## Addendum No. 2

**PROJECT:** Phase 1 Lower Level Improvements for the  
for the Beekman Library

**PROJECT N°:** 22•46•09

**DATE:** 6 October 2023

PROJECT NAME	PHASE 1 LOWER LEVEL IMPROVEMENTS FOR THE BEEKMAN LIBRARY	DC NO. SK A103-11R
DRAWN BY:	PROJECT NO: 22-46-09	
CHECKED BY:	SCALE: NOT TO SCALE

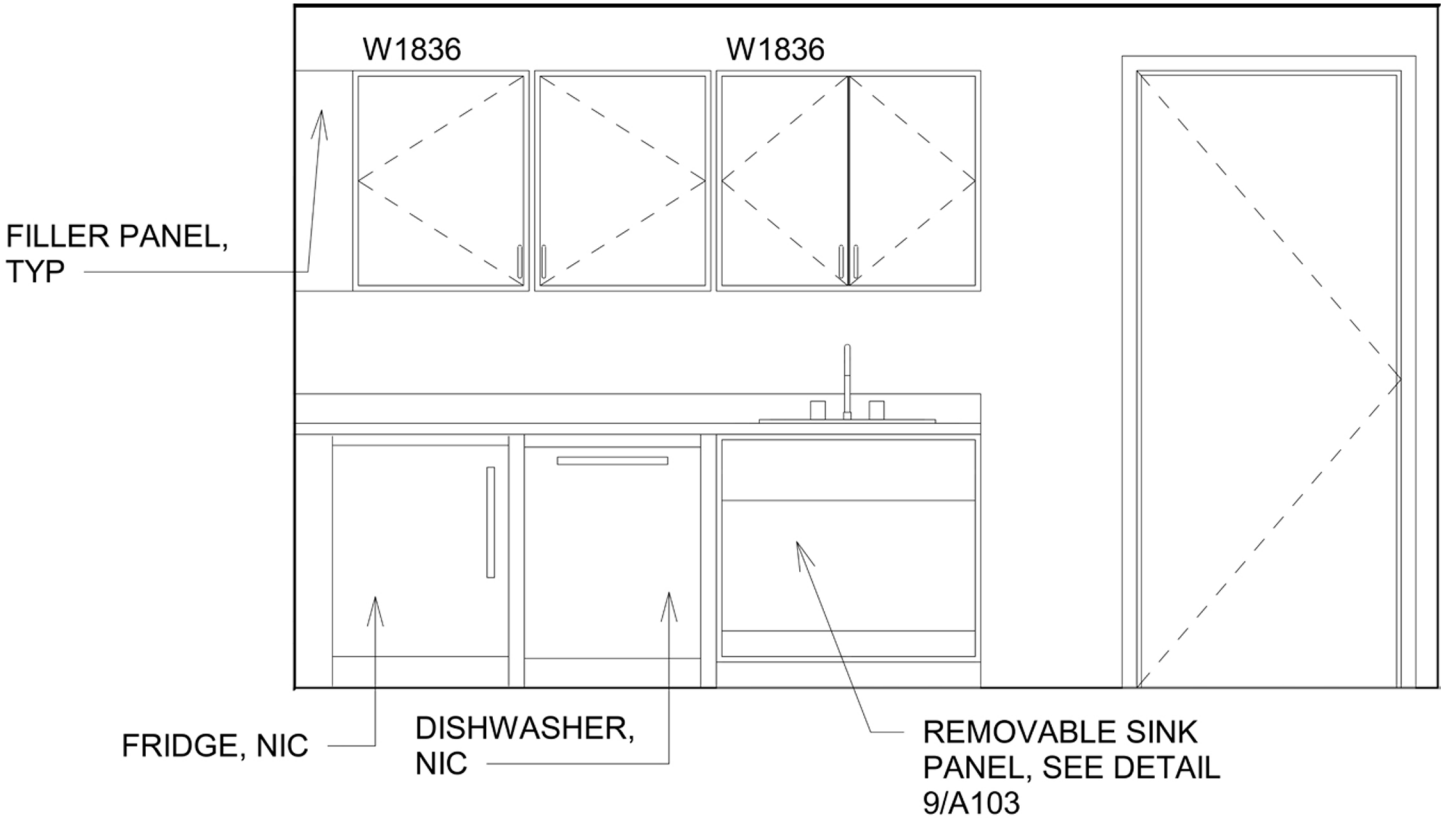
**4. 11 / A103 Kitchenette Elevation**

Replace elevation with attached Sketch Detail SK A103-11R."
